Fab FFF8

PH-15363

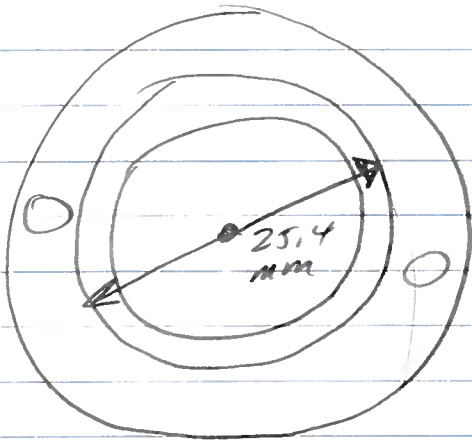
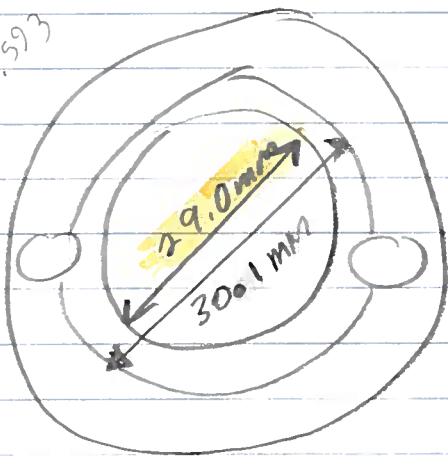
increase opening to $29.0 \pm \begin{matrix} 0.0 \\ 0.1 \end{matrix}$ mm

increase lip to $30.1 \begin{matrix} +0.1 \\ -0.0 \end{matrix}$ mm

4 Ports.
